Access Compliance Report

Public Rights-of-Way

Intersection ID: 18026	Main Street: E_INDEPENDENCE_BV	Cross Street: WALLACE_LN	Location: NW
ADA ID: 96F4CCD78F78	Ramp Type: Perp	Initial Pass/Fail: Fail	Overall Compliance: No
		Severity Score: 12.5

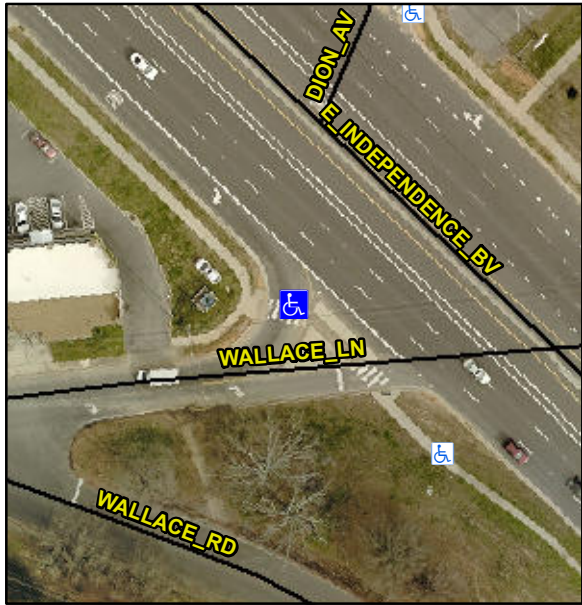
Codes/Mitigation Info/Possible Solution			Field Measurements/Component Compliance					
	Possible Solutions:		Compliance	Description	Data	Compliance	Description	Data
	Remove & Replace Entire Ramp.		N/A	Ramp Length (in)	73.0	No	Ramp Slope (%)	10.0
			Yes	Ramp Width (in)	60.0	Yes	Ramp XSlope (%)	0.7
			N/A	Flare Type LT	N/A	N/A	Flare Type RT	N/A
			N/A	Flare Slope LT (%)	N/A	N/A	Flare Slope RT (%)	N/A
			N/A	Flare Traversable LT?	N/A	N/A	Flare Traversable RT?	N/A
			N/A	Landing Length (in)	N/A	N/A	DWS Provided?	N/A
			N/A	Landing Width (in)	N/A	N/A	DWS Contrast?	N/A
			N/A	Landing Slope (%)	N/A	N/A	DWS Length (in)	N/A
			N/A	Landing X Slope (%)	N/A	N/A	DWS Full Width?	N/A
Surveyor Notes: N/A			N/A	Landing Curb? (Y/N)	N/A	N/A	DWS Offset (in)	N/A
			N/A	Shared Landing?	N/A			
			N/A	Gutter Ponding?	N/A	N/A	Gutter Slope (%)	N/A
			N/A	Gutter Lip Ht (in)	N/A	N/A	Gutter X Slope (%)	N/A
			N/A	Painted X Walk1?	Yes	N/A	Painted X Walk2?	N/A

X Walk 1 Direction	To SE		X Walk 2 Direction	N/A
			N/A	X Walk 1 Width (in)	120.0	N/A	X Walk 2 Width (in)	N/A
				X Walk 1 Slope (%)	0.8		X Walk 2 Slope (%)	N/A
				X Walk 1 X Slope (%)	0.4		X Walk 2 X Slope (%)	N/A
			N/A	Ramp inside XWalk1?	Yes	N/A	Ramp inside XWalk2?	N/A
PROW/ADA: R304.2.2				Road Slope (%)	N/A	N/A	Clear Space?	N/A
				Road X Slope (%)	N/A	N/A	Clear Space to XWalk (in)	N/A
			N/A	Any Obstructions?	N/A	N/A	Storm Grate/Utility Hazard?	N/A
				Obstruction Type			Storm Grate/Utility Type	
					N/A			N/A
						Yes	Surface Condition? (G/P)	Good
Total Cost:		\$	1850.00
